Re: Proposed Hetfield Project; Draft EIR dated January 14, 2011

Re: Draft Hetfield EIR dated January 14, 2011

Re: Proposed Hetfield Estates Project: Draft EIR dated January 14, 2011

Fiorindo Backyard - 1112 Sanders Dr. 2002

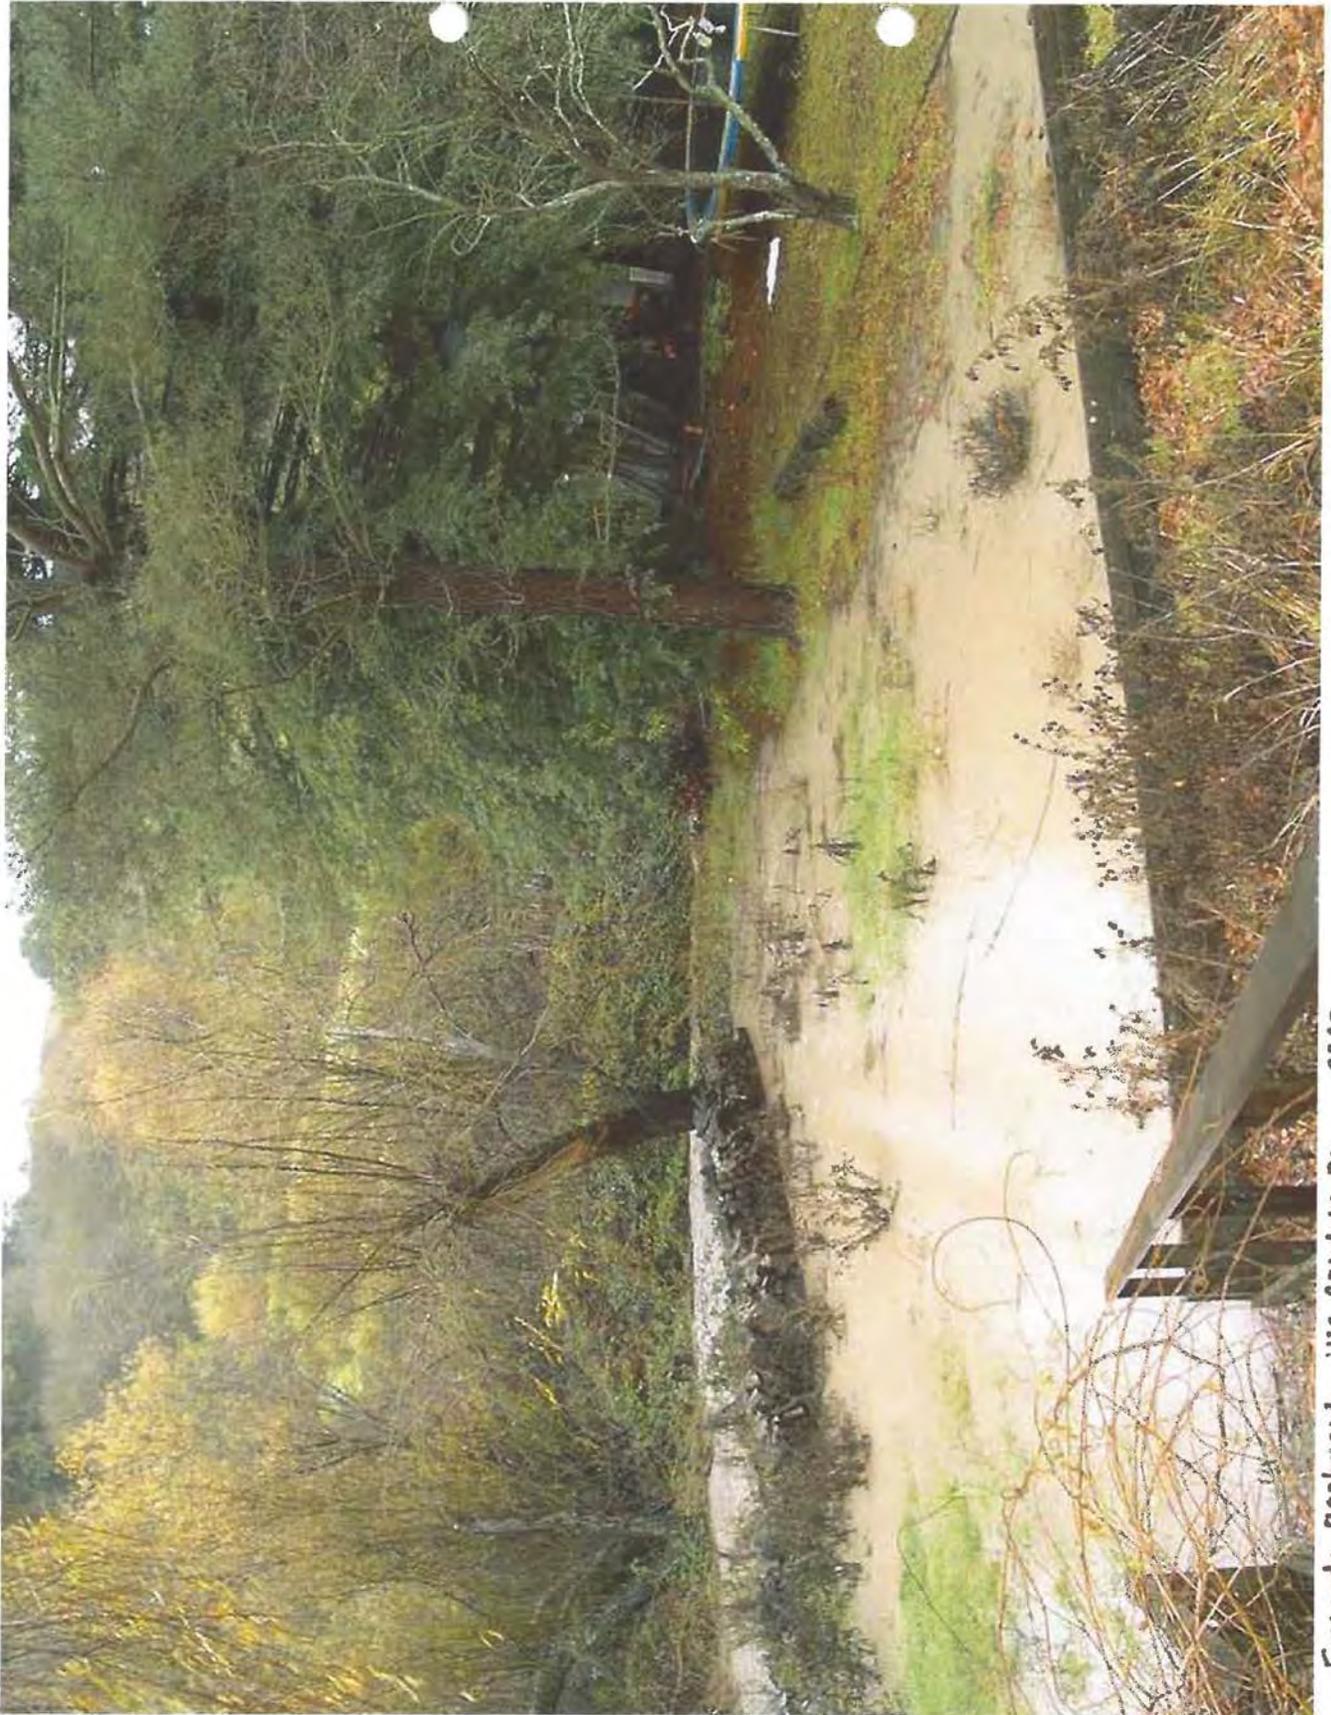
Also, please note that the first picture that was displayed during the public hearing was taken in 2002 and showed the Larch Creek overflow before any backyard improvements were made. The second picture displayed was taken in 2006 and shows the overflow of the Larch Creek after we had the backyard area graded and the elevation brought up so that the water would not be retained on the area. The photos are attached to this email for your review. Since the flood in 2006, after we enhanced our backyard, we did alter the northern bank of Larch Creek by placing rip rap along on our property along the curve of the creek to restrain further flooding. In no way do the improvements we made to our backyard increase the likelihood of flooding on our property or elsewhere. On the contrary – we have enhanced our property to restrict further flooding from the natural flow of the Larch Creek.

- 6-2 **Comment:** States that backyard improvements at 1112 Sanders Drive do not increase likelihood of flooding in Larch Creek.

**Response:** Although Mills Associates has not visited the back yard at 1112 Sanders Drive, it is assumed that the riprap that has been installed to protect the property from further erosion does not reduce the flow capacity of Larch Creek at that location.

FIGURE 2  
CROSS-SECTION A - A'  
35 HETFIELD PLACE  
MORAGA, CA

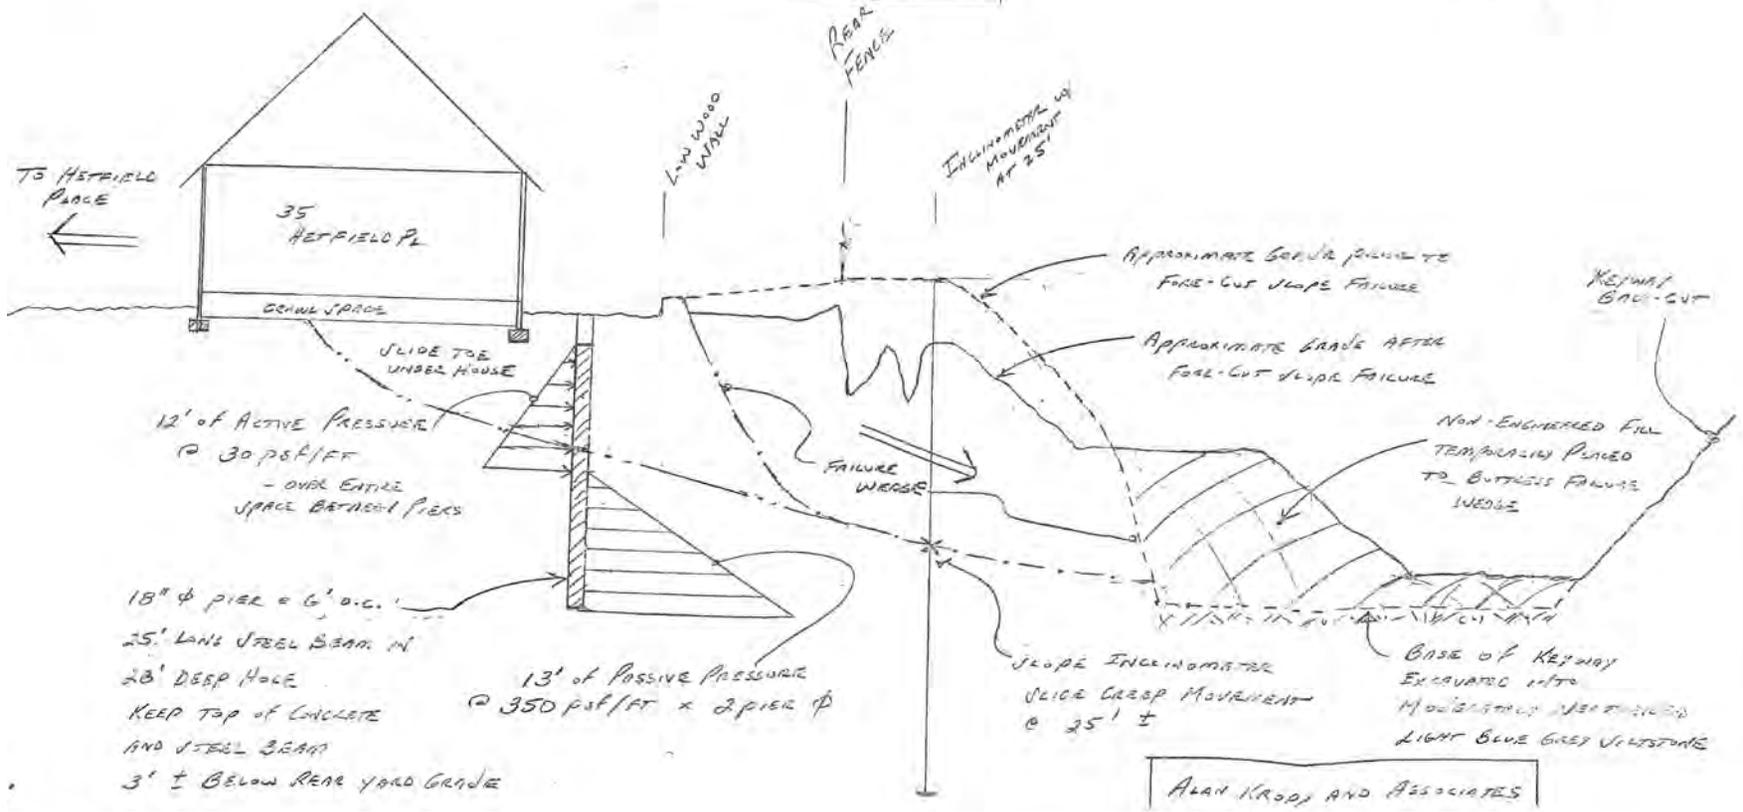
First, the slide was a different shape and in a somewhat different location than was thought. This is shown on the attached color copy. A repair that was originally scheduled to be 3-4 weeks in duration instead took from August 25 through November 1, 2009, or 10 weeks. Secondly, during the repair, there was an unexpected failure that caused a large wedge (about 30 feet wide) of soil to collapse into the excavation. (See Figure 2, black and white copy). This failure endangered my house and an emergency installation of 12 stitch piers was required before work could continue. These piers are 28 feet deep, 18 inches in diameter, and have a 25 foot long steel beam down the center of each one, with concrete filling the remaining space.

Having seen firsthand the uncertainty and risks that accompany a large project in the unstable hillsides of the neighborhood, it is important that the developers be required to post a suitable bond in connection with the grading and the construction of the new homes. The neighboring homeowners need to be protected from the large potential liabilities if similar issues arise during the Hetfield Estates project. The developer also must be required to do sufficient work to leave the land in stable condition if the scope of the required excavation and slide repair exceeds what is expected to such an extent that the developer decides to abandon the project. Again, this can be ensured with the use of a suitable bond. As I have learned, the geology is an inexact science, and even hiring the best expertise available and gathering data in advance is no guarantee that all will go as planned.

7-1 **Comment:** States that the developer should post an adequate bond in connection with grading and construction of the new homes as an additional measure for hazards associated with unstable geologic conditions.

**Response:** As a condition of approval, the Town will require the applicant to post bonds to ensure completion of the site improvement work. As a point of clarification, bonds are not appropriate to address applicant's potential liability for harm to persons or property. The applicant will be required to provide evidence of adequate liability and other insurance. The GHAD will bear ongoing responsibility for maintenance and repair of geological hazards on the property.
